UNITED STATES PATENT AND TRADEMARK OFFICE

Office Action Summary	Application No.	Applicant(s)	
	10/676,067	MATSUEDA ET AL.	
	Examiner	Art Unit	
	Dieu Hien T. Duong	2821

DETAILED ACTION

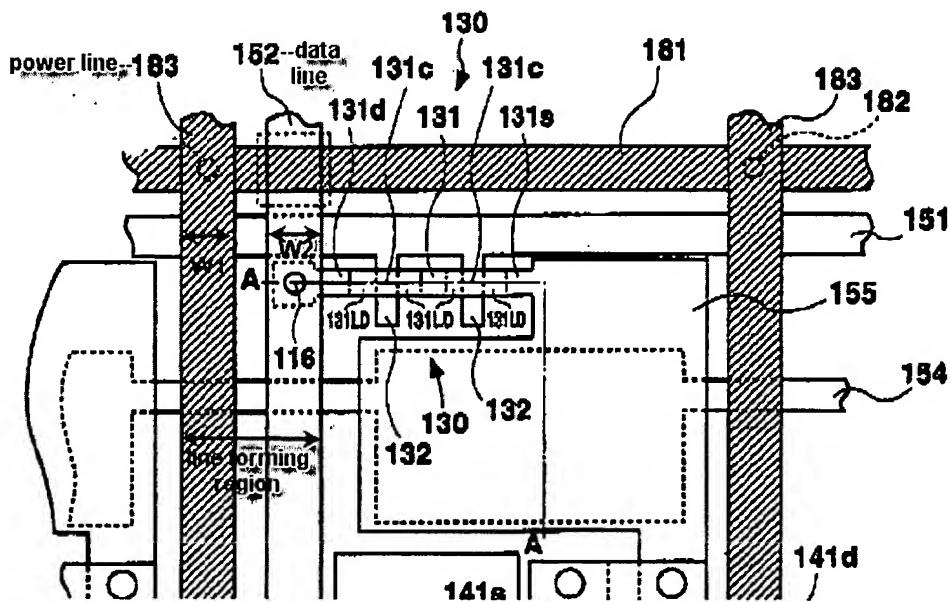
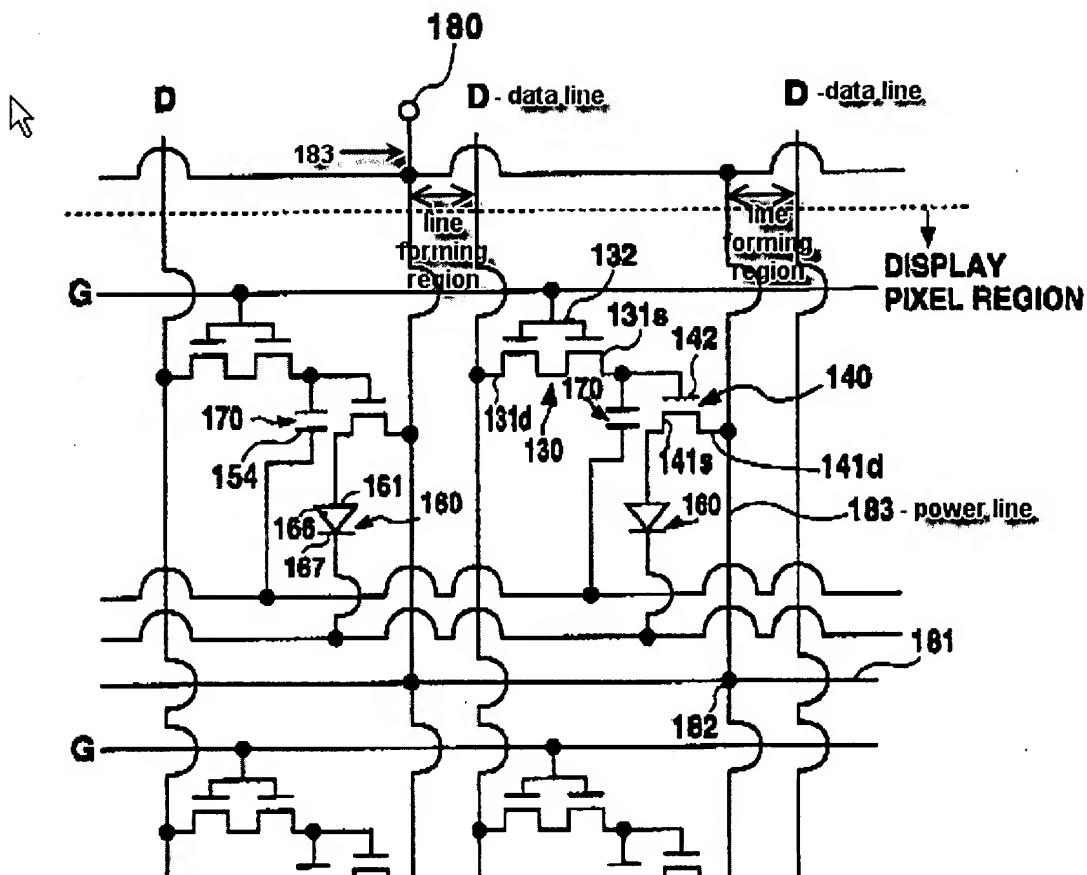
Regarding claim 1, Komiya discloses, in Figures 4-5 and page 5, par. [0067], liens 7-9, an electro-optical device, comprising an electric power supply circuit (180); a plurality of pixels disposed in the form of a matrix, including electro-optical devices driven by receiving electric power from the electric power supply circuit (Fig. 5), the plurality of pixels making up a plurality of pixel groups formed of a series of pixels arrayed in at least one direction of the row direction and the column direction (Fig. 5), line forming regions (183, D) being formed between adjacent pixel groups of the plurality of pixel groups, and the line forming regions (183, D) being formed with generally the same width; a sum of widths (183, D) of a plurality of lines formed in one

line forming region is approximately the same as that of a sum of widths of a plurality of lines formed in another line forming region (183, D); a plurality of electric power lines (183) to supply driving voltage to the electro-optical devices.

Komiya does not disclose electric power lines with different widths.

Yamazaki discloses, in Figure 1B and page 6, lines 5-15, electric power lines with different widths.

It would have thus been obvious to one having ordinary skill in the art at the time the invention was made to include the electric power lines with different widths of Yamazaki in the display device of Komiya to achieve the claimed invention, doing so would improve the brightness uniformity of the display device (col. 3, lines 62-67).

In response to the first argument, in Office Action mailed May 16, 2007, Komiya discloses, in Figures 4-5, a sum of the widths of a plurality of lines (183, D) including at least one electric power line (183) formed in one line forming region is approximately the same as that of a sum of the widths of a plurality of lines (183, D) formed in another line forming region. Each line forming region includes the power line 183 and data line D in Figure 5 (or data line 152 in Figure 4). Therefore, sum (183 + D) or of the widths of a plurality of lines (183, D) including at least one electric power line (183) formed in one line forming region is approximately the same as that of a sum (183 +D) of the widths of a plurality of lines (183, D) formed in another line forming region.

In response to the second argument, Komiya discloses the line width of power line 183 can be as large as the width of the signal line 152, or even larger (see lines 7-9 of par. [0067]). In other words, the width of the power line 183 can be changed to prevent lack of display luminance. Therefore, It is proper to combine Komiya with Yamaki to provide the electric power lines with different widths wherein the sum of the widths of a plurality of lines in one line forming
